Change No. 3
License No. DPR-38

Change No. 1 to the Technical Specifications, Appendix A, to Operating License No. DPR-38 for the Oconee Unit 1 plant, limited power operations to 75% of full rated power for an interim period until we have completed our evaluation of fuel densification.

Technical Specifications 1.6, 1.8, 2.1, 2.3, 3.1.3, 3.5.2, 3.11, 4.1 and 4.7 are revised as the enclosure to this letter. This change will be known as Change No. 3 to the Technical Specifications, License DPR-38 and is effective on date of issuance.

Figure 2.1 - 2

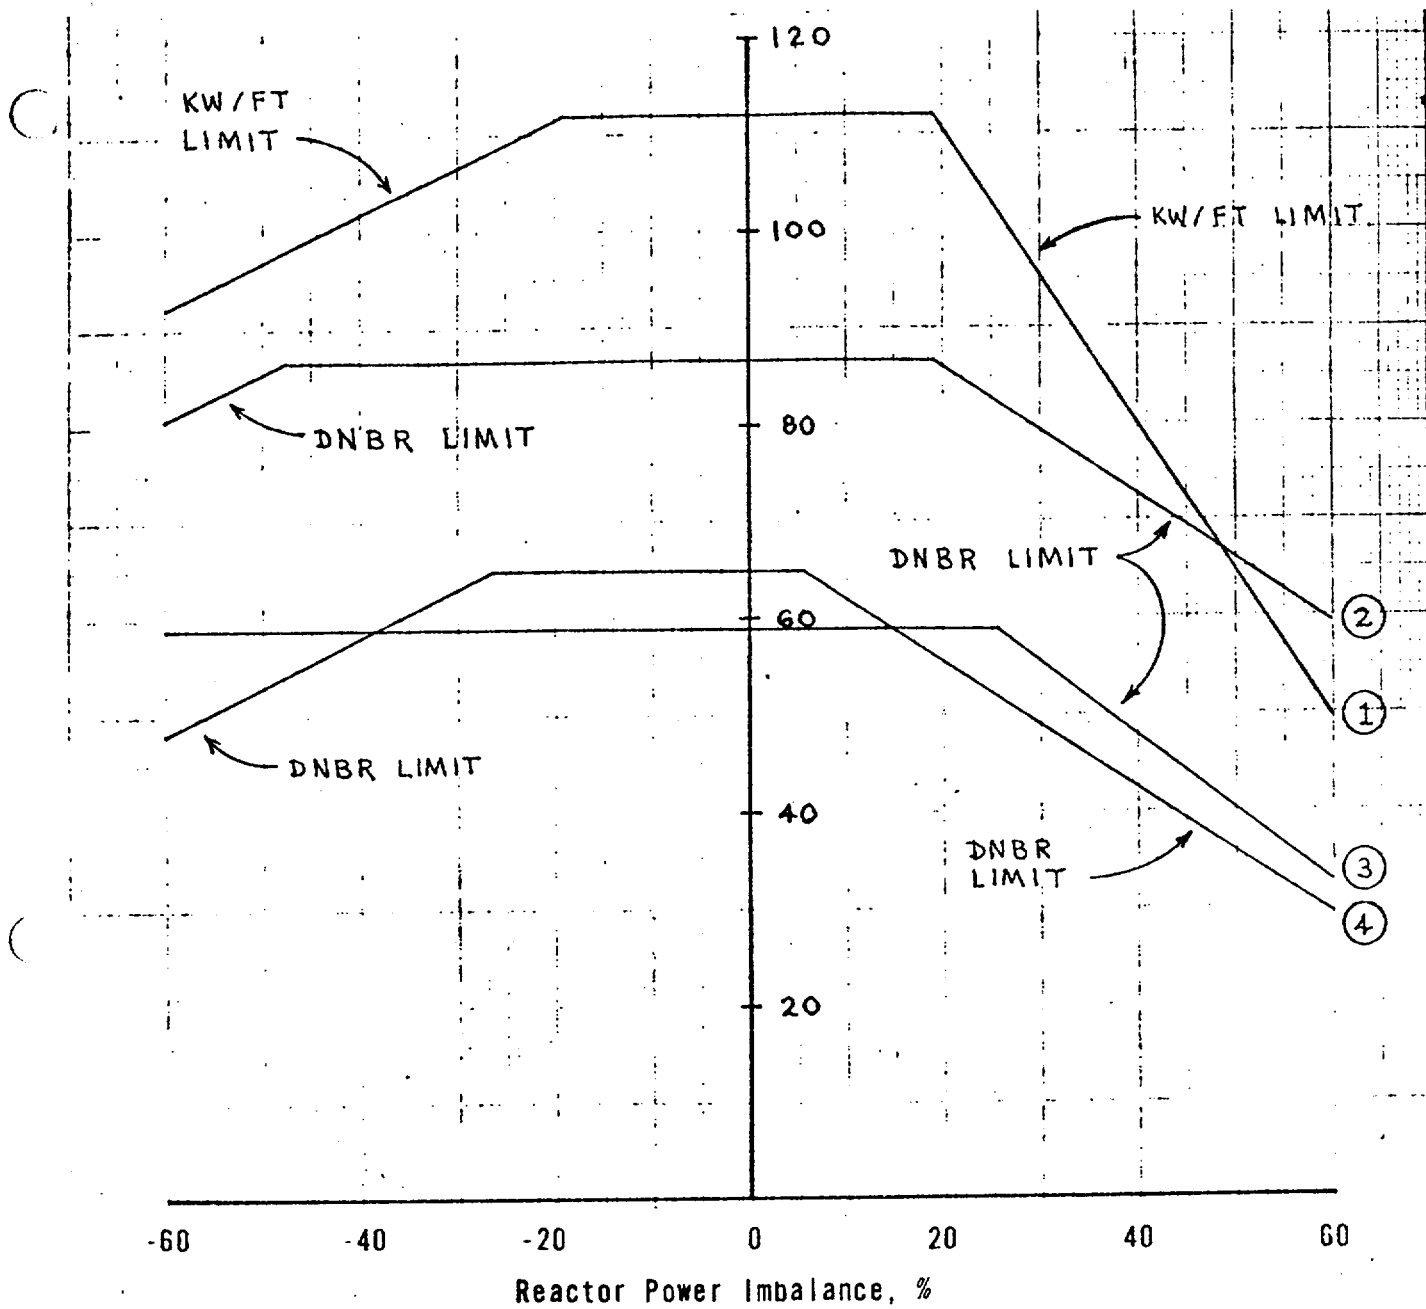
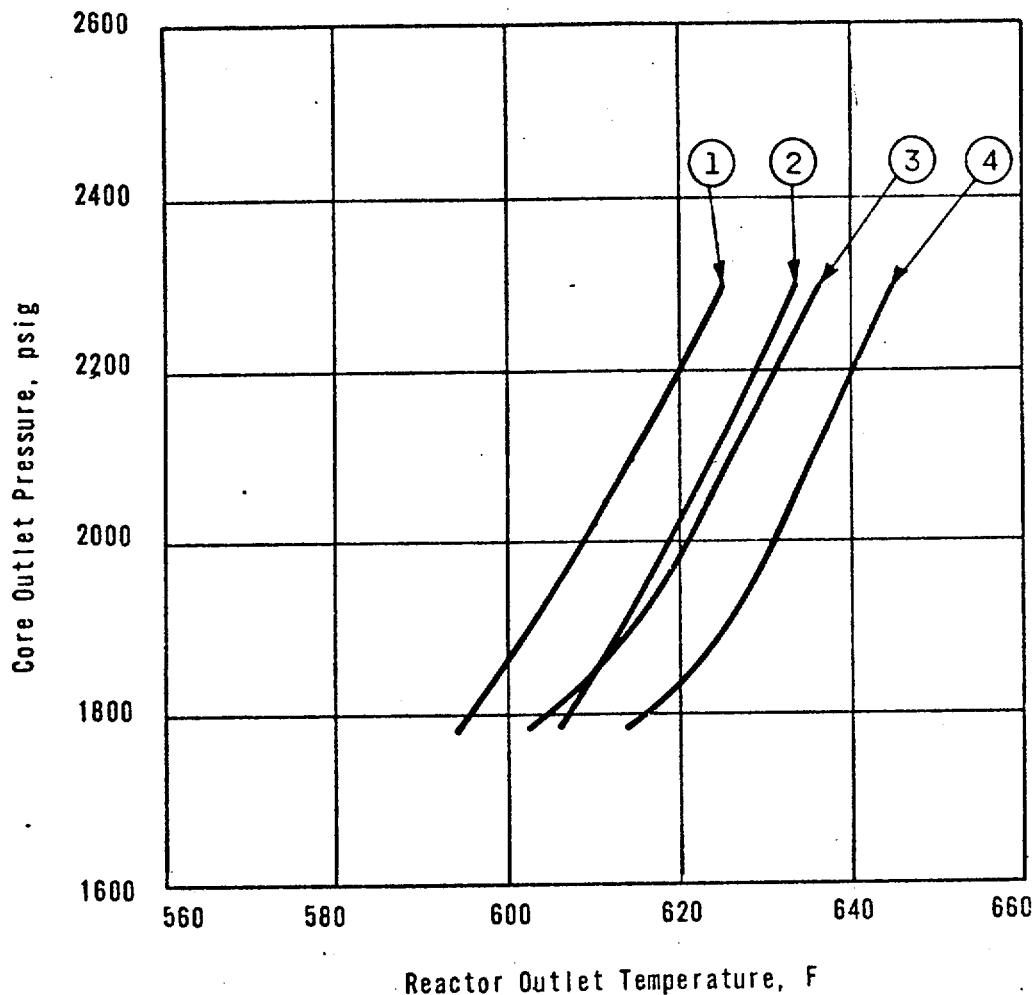
The curves of Figure 2.1-2 are based on the more restrictive of two thermal limits and include the effects of potential fuel densification:

The specified flow rates for curves 1, 2, 3, and 4 of Figure 2.1-2 correspond to the expected minimum flow rates with four pumps, three pumps, one pump in each loop and two pumps in one loop, respectively.

Figure 2.3 - 1

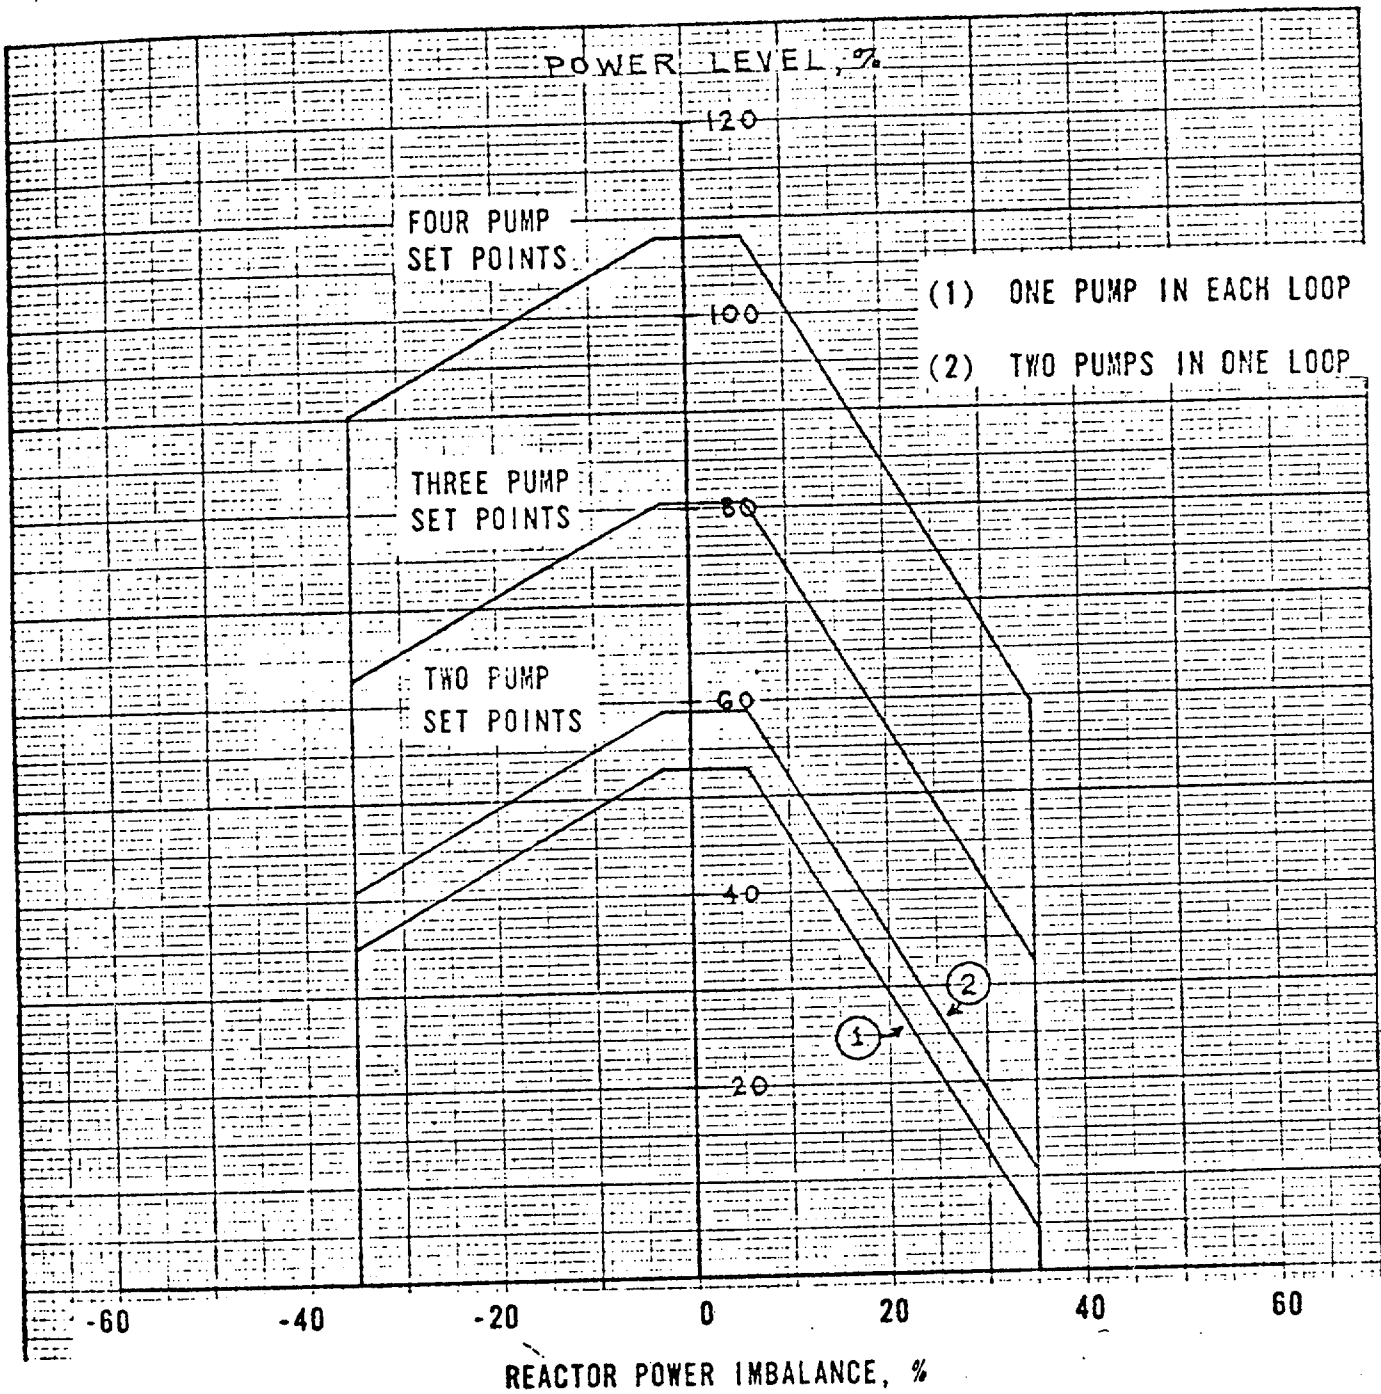
During a startup accident from low power or a slow rod withdrawal from high power, the system high pressure set point is reached before the nuclear overpower trip set point. The trip setting limit shown in Figure 2.3-1 for high reactor coolant system pressure (2355 psig) has been established to maintain the system pressure below the safety limit (2750 psig) for any design transient.⁽¹⁾

The low pressure (1800 psig) and variable low pressure ($16.25T_{out} - 7769$) trip setpoint shown in Figure 2.3-1 have been established to maintain the DNB ratio greater than or equal to 1.3 for those design accidents that result in a pressure reduction.^(2,3)

The high reactor coolant outlet temperature trip setting limit (619 F) shown in Figure 2.3-1 has been established to prevent excessive core coolant temperatures in the operating range. Due to calibration and instrumentation errors, the safety analysis used a trip set point of 620 F.
